SETHI HOUSE, PESHAWAR

SITE INSTRUCTIONS

CONSERVATION RECORD DOCUMENT
Site Instructions Sheet

Title of Works:
Construction of East Purdah Wall in Brick Masonry

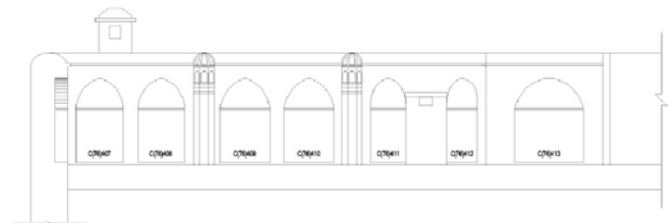
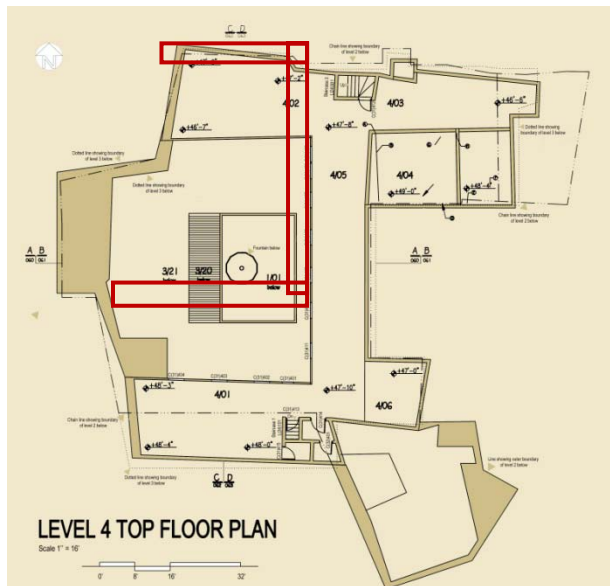
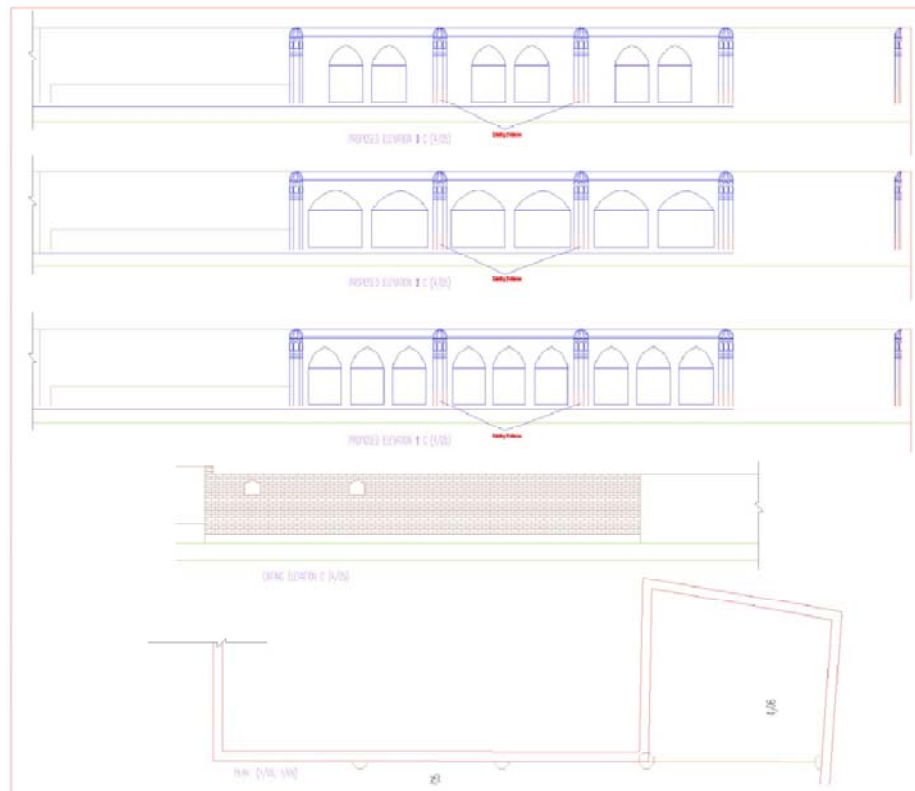
1. North Purdah wall found to be in original conditions where as remaining masonry purdah walls have suffered alteration.
 - 4/06: New Wall, no decorative features, uneven masonry
 - 4/05: New Wall, roots of tree piercing through, cracks and titling
 - 4/01: Wall partitioning Nisar Sethi's house is a new construction constructed of G.I sheet with steel framing.
 - 4/02: Only remaining evidence of Original Purdah wall
2. New additions to be removed and replaced with new construction based on evidence of original purdah wall along North 4/02
3. Design elements using North Purdah Wall spacing and attached pilasters
4. 8" wall to be constructed. Reuse Bricks from other areas to minimize the use of new bricks
5. Bases and crowns of new pilasters to mock original
6. Use white lime-lime powder (1:3) mix for mortar.

Title of Works:
Dismantling Flooring level 2; New Waterproofing

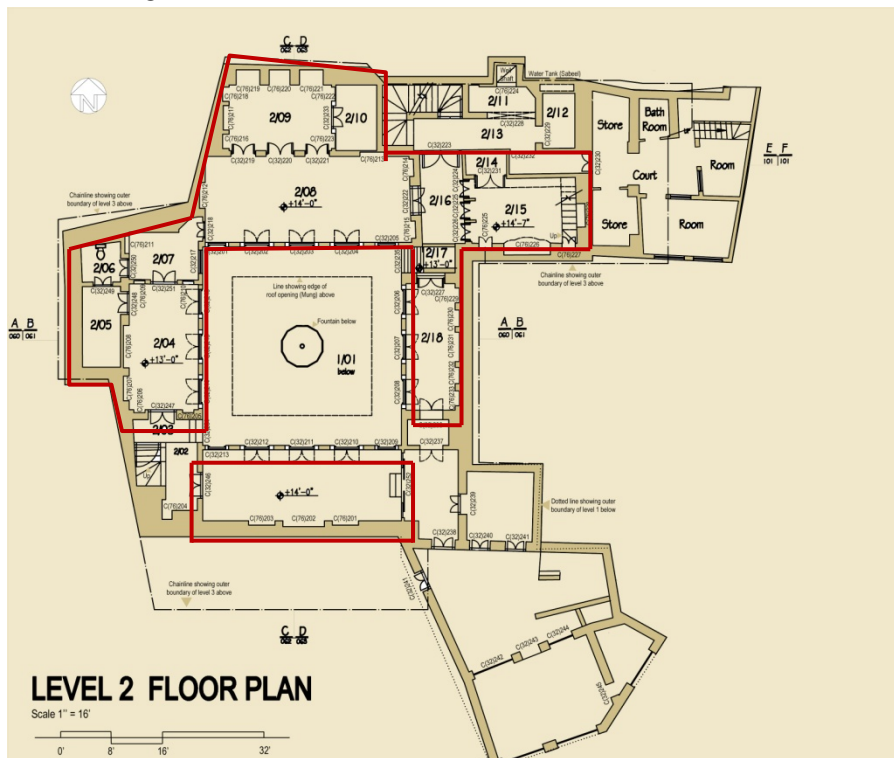
1. Reasons for Dismantling Flooring
 - Flooring was uneven
 - Investigation carried out showed that brickwork on floor employed new bricks. Originally lime terracing was used.

- Due to fears that flooring may be in a similar condition as roof level 4 where the timber structure was badly damaged. Further evidence of water retention was visible bulges in floor.

2. Floor level: Investigation led to further understanding of actual floor levels. It was found that the level of timber works such as doors and cupboards was below the existing floor level.

3. Removal: All tile flooring and lime terracing to be removed
4. Timber: Treat all wooden joists and rafters as in ROOF level 3, 4 to stabilize structure and make serviceable.

5. Fill gaps with tiles or timber fillers to even surface
6. Anti-Termite: All structural woodwork must be treated with 2-3 coats of anti-termite, BILFEX, of German origin.

7. Fill with lime terrace to level of original floor as per investigation
8. Do not apply final lime terracing or brick flooring till decision in this regards has been taken

Dismantling Flooring level 3; New Waterproofing

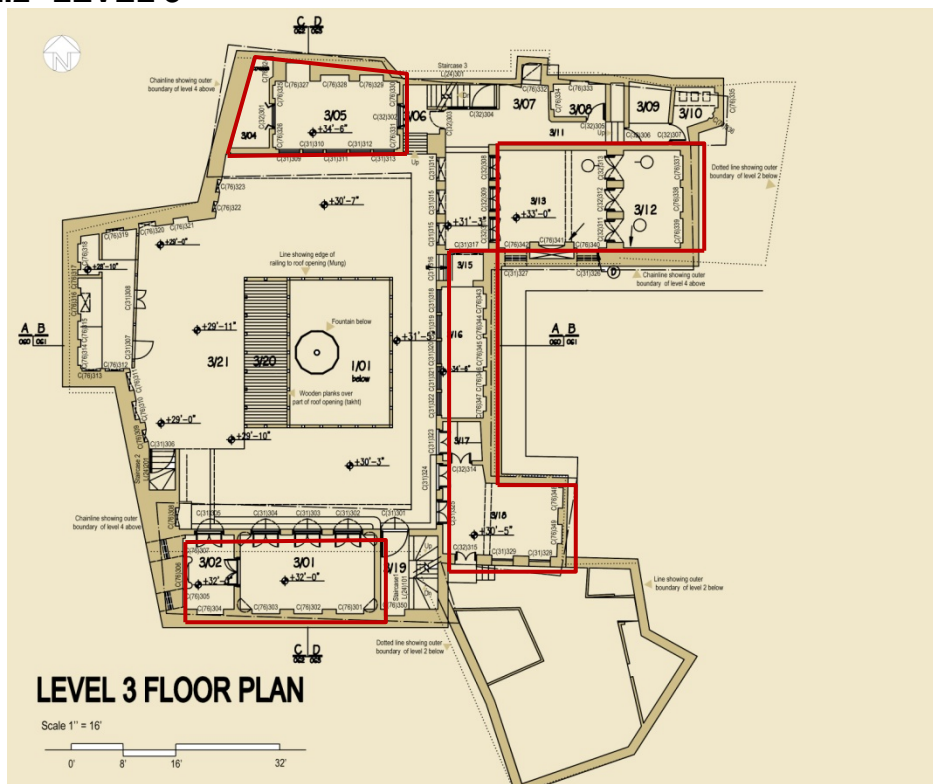
- Reasons for Dismantling Flooring
 - Flooring was uneven
 - Investigation carried out showed that brickwork on floor employed new bricks. Originally lime terracing was used.

- Due to fears that flooring may be in a similar condition as roof level 4 where the timber structure was badly damaged. Further evidence of water retention was visible in the tarseem bandi of roofs on level two rooms.

- Floor level: Investigation led to further understanding of actual floor levels. It was found that the level of timber works such as doors and cupboards was below the existing floor level.

- Removal: All tile flooring and lime terracing to be removed
- Timber: Treat all wooden joists and rafters as in ROOF level 3, 4 to stabilize structure and make serviceable.

- Fill gaps with tiles of timber fillers to even surface
- Anti-Termite: All structural woodwork must be treated with 2-3 coats of anti-termite, BILFEX, of German origin.

- Fill with lime terrace to level of original floor as per investigation
- Do not apply final lime terracing or brick flooring till decision in this regards has been taken

Title of Works:
Tarseem Bandi

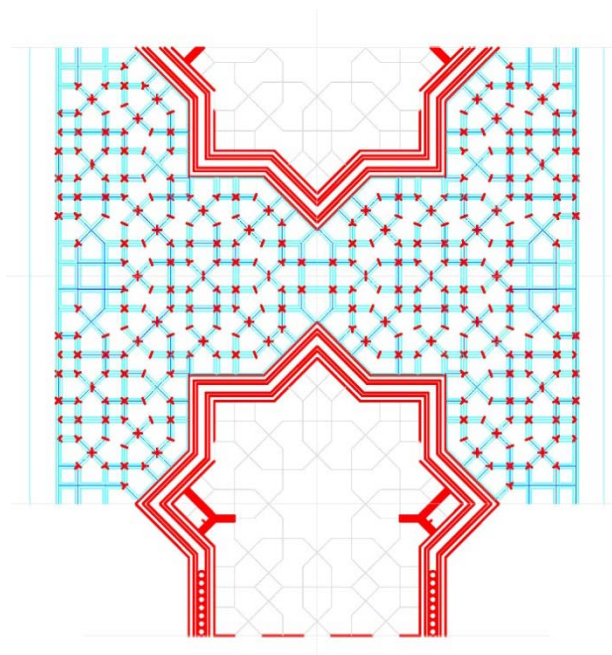
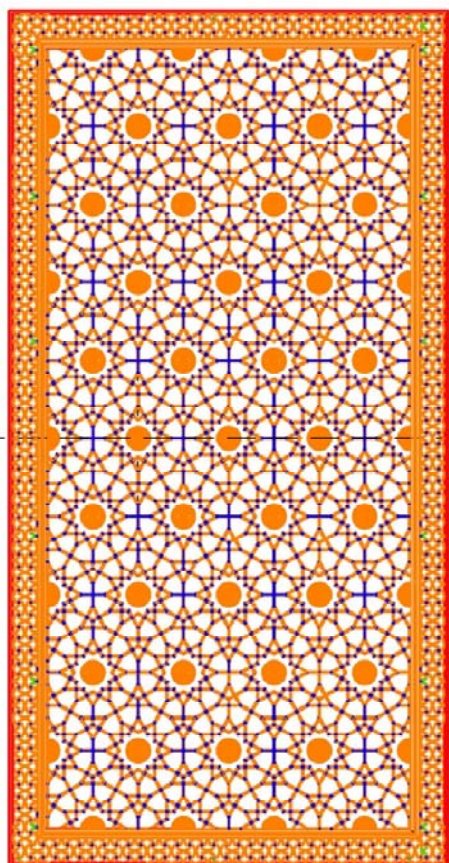
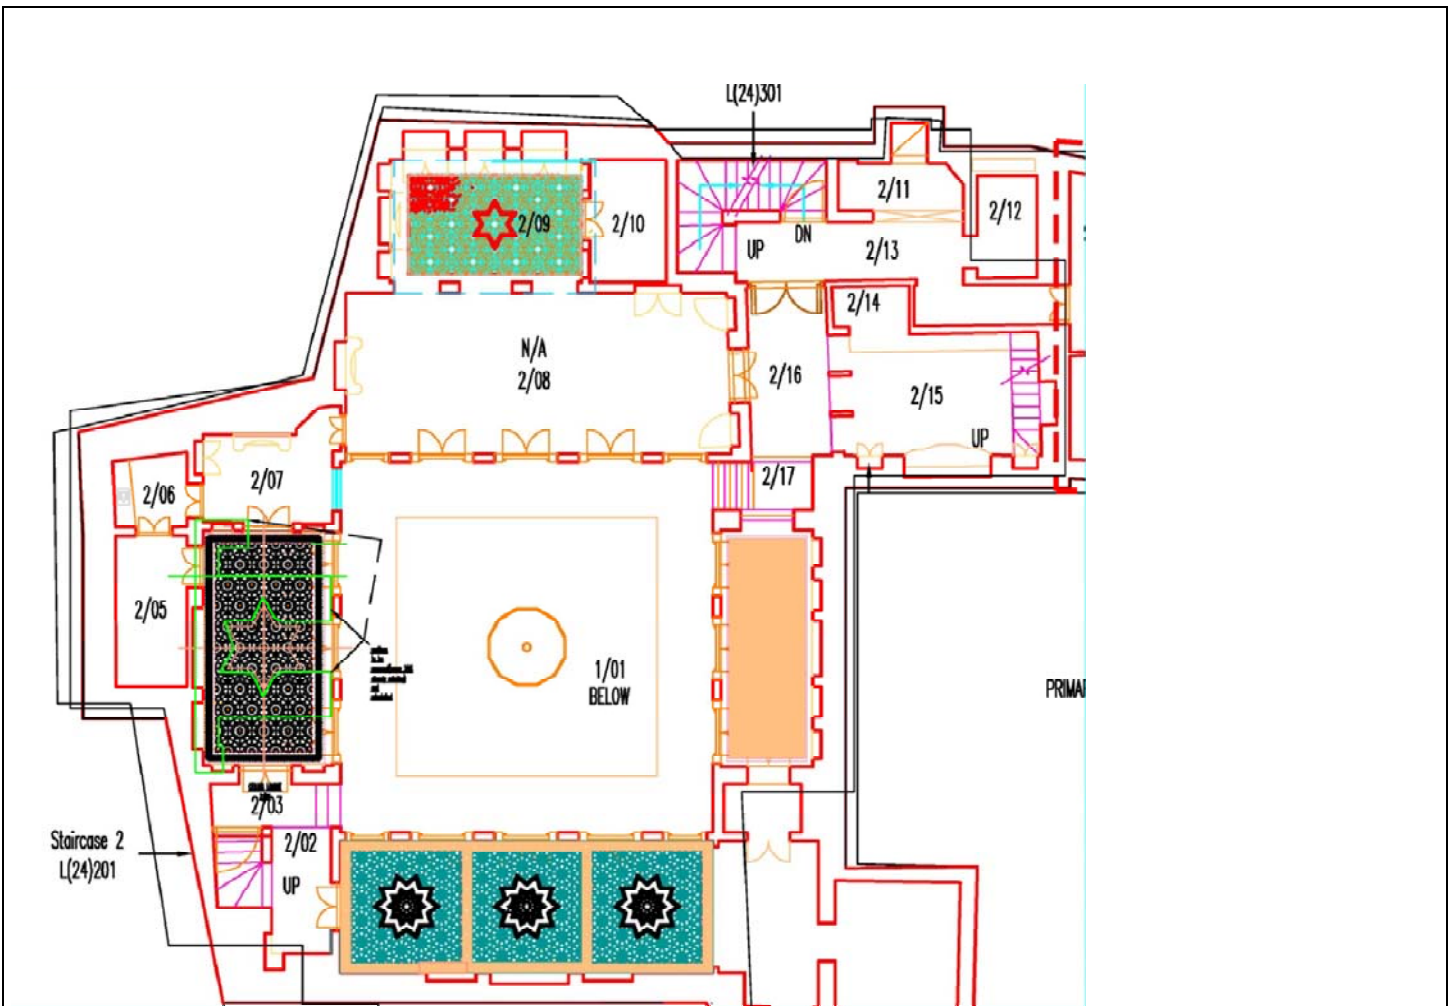
1. Check framing of wooden structure above
2. Make drawings of exact size, shape, profile of each unique element
3. Make exact replicas of wooden beading
4. Refix wooden beading according to exact location as recorded on drawings
5. Leave all new tarseem bandi without any treatment, so that the new work is clearly visible until further decision has been taken regarding finishing

Title of Works:
Tarseem Bandi Room 2/04

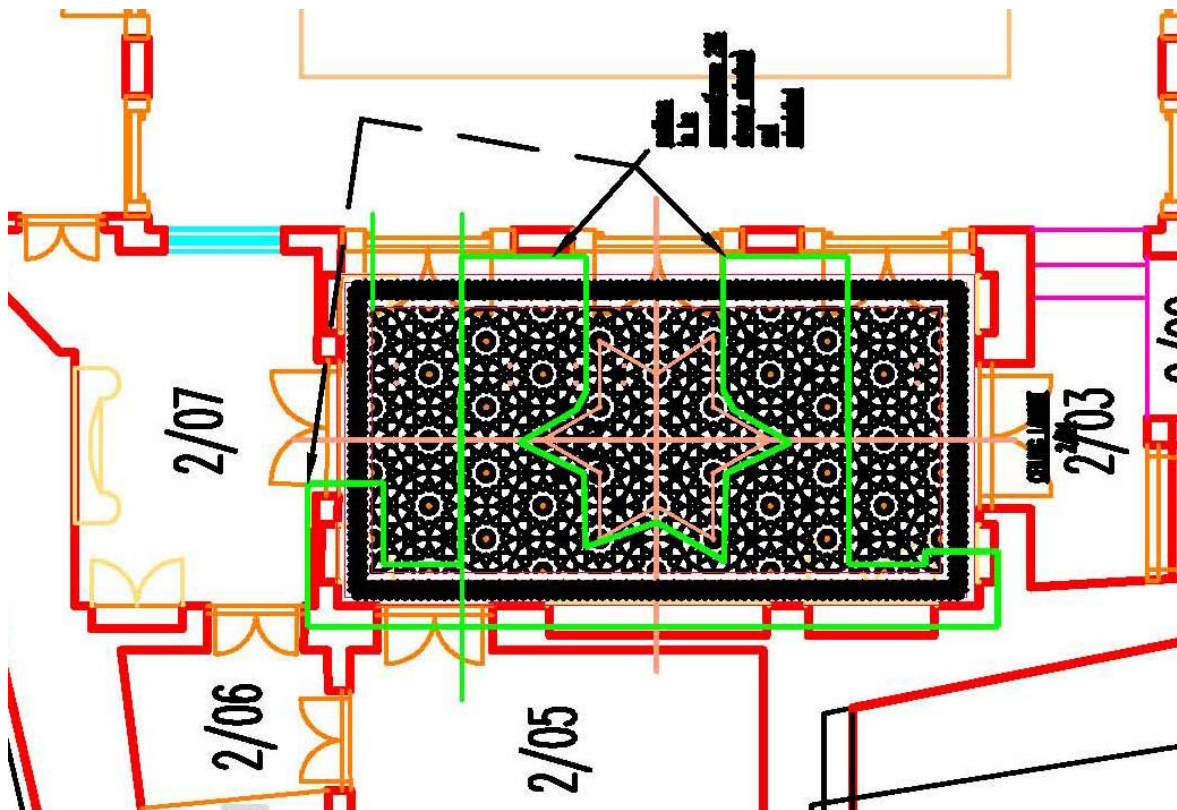
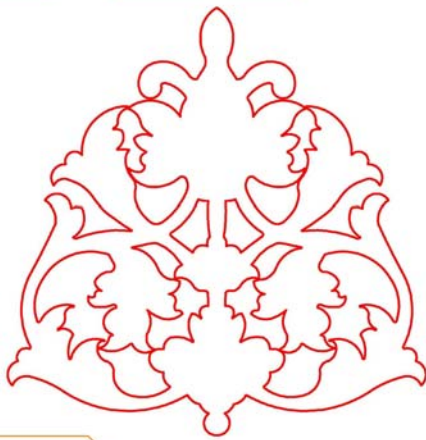
1. In view of unsuccessful investigation to locate skilled artisans in Peshawar for the production of the decorative moldings to be attached to the wooden beading of tarseem bandi, it has been decided that Mr. Zulfiqar Gondal should proceed in getting the moldings prefabricated through laser cutting technique in Lahore.
2. Decorative flower piece to be cut into ¼" thick MDF board. Computer aided Digital production machines to be employed
3. A plate for each decorative molding must also be prefabricated.
4. The decorative flower motifs are to be stuck onto the plate with German glue and screwed onto the

Plan Showing holes that are needed to be made in basement floor

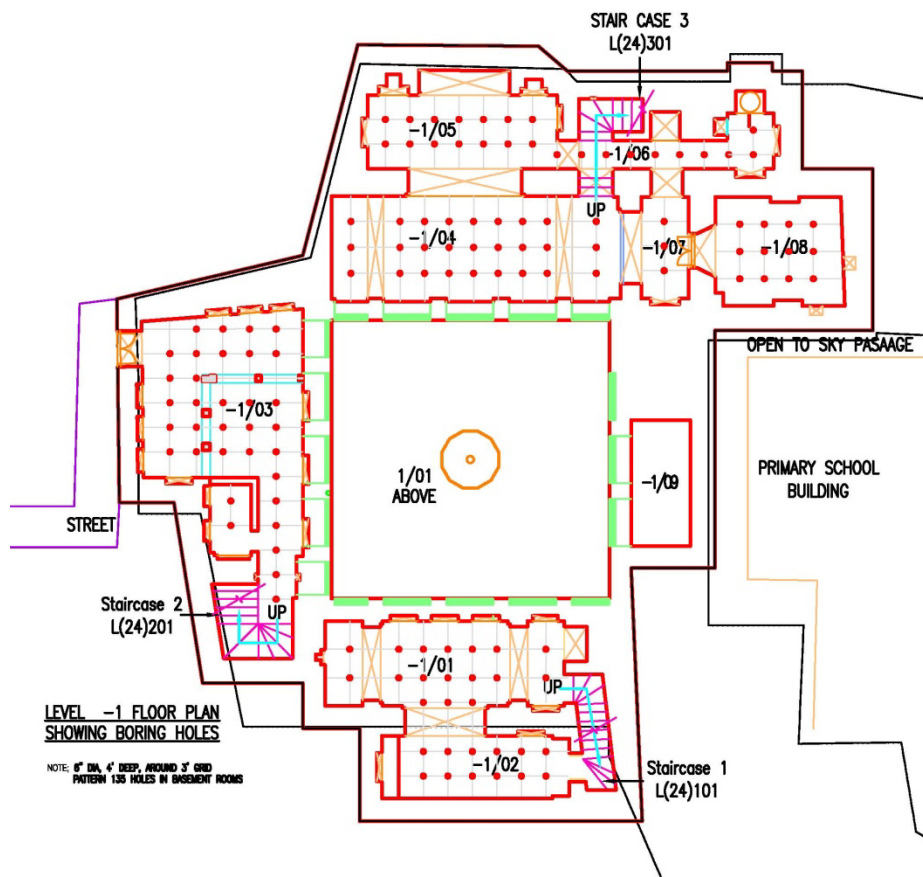
1. Investigation: Geotechnical survey was conducted to investigate the reason for inordinate bulge in basement flooring. Geotechnical Engineer, MR. Ejaz Shahid advised the work that had to be undertaken in order to remove the dampness in the basement causing the damage.
2. Removal: Original brick removed
3. Removal: Earth filling up to 1 foot
4. 6"x6" holes to be dug 4 feet deep into the ground along centres marked on the drawings
5. All holes to be filled with pebbles with 1" – 2" diameter
6. Entire surface to be filled with 6"-7" sand
7. Finish with 3" lime terracing 1" below original floor level as determined on site.

NOTE: Remaining 1" left to be later filled with 1"th brick tile or 1"th lime terracing, depending upon decision.
